**Planning Permit Application PA2201497  
519 Orrong Road, Armadale**

We continue to act for The King David School in relation to this matter and refer to your letter dated 4 February, 2022, requesting further information pursuant to Section 54(1) of the *Planning and Environment Act 1987*.

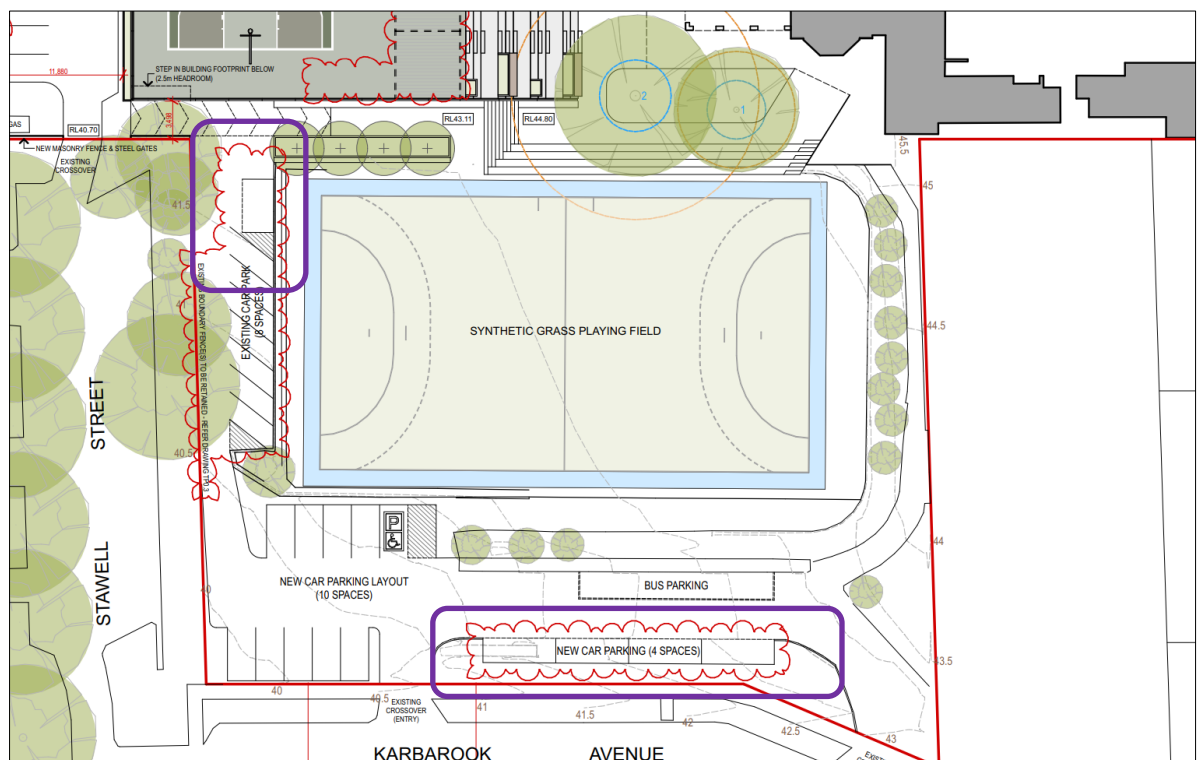
- 1. The Department is concerned a corrective manoeuvre is required for vehicles accessing the existing angled parking on the west side of the outdoor sports field. The Department does not agree with the Traffic Engineering Report's assessment that this corrective manoeuvre is unavoidable.***

Our client has reviewed this comment and proposes to reconfigure the existing car parking spaces to the west and south of the existing synthetic sports ground to ensure that the correctional manoeuvre is not required whilst retaining the same number of on-site car parking spaces. Please refer to the enclosed amended plans and below in purple:

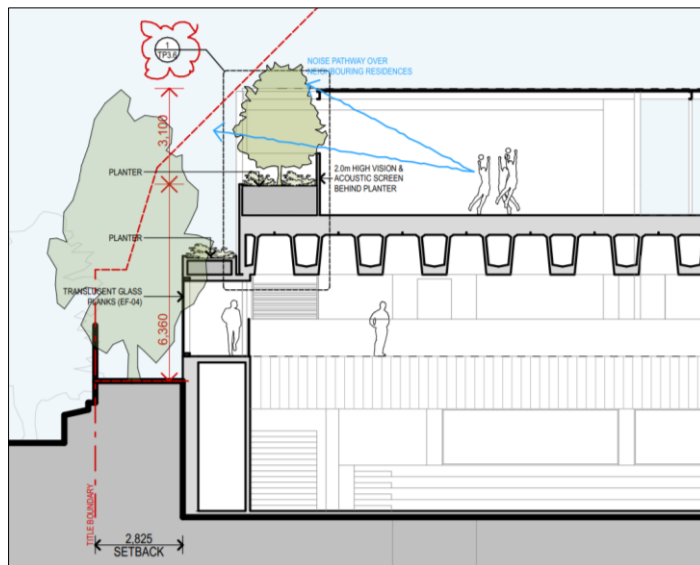
- 2. The Department is concerned the proposed side setback to the northern boundary does not appropriately respect the amenity of adjoining properties on Larnook Street.***

The northern boundary setback of the proposed building has been carefully considered in terms of the relationship with the adjoining residential properties.

The interface has been addressed through:

- The sinking of the building into the site topography, such that the lower level is almost entirely below the natural ground level of the subject site;

- The retention of as many existing trees as possible, and supplementary planting through native evergreen (waterhousia) planted at 2.5m installation size;

- The use of tiered setbacks for the upper level and roof terrace playing surface which provides for articulation of the building form in a vertical fashion;

- The installation of a planter at the upper level of the building (above the viewing link zone) to soften the building appearance;
- The implementation of a planter at the playing surface level, up to 7.1m setback from the Title, to provide for horizontal building articulation of the building;

- The use of 'Wimbledon green' as a muted tone to soften the building appearance and integrate with the landscape buffer;
- The use of opaque materials to avoid overlooking; and

- The application of acoustic attenuation treatments to prevent noise impacts.
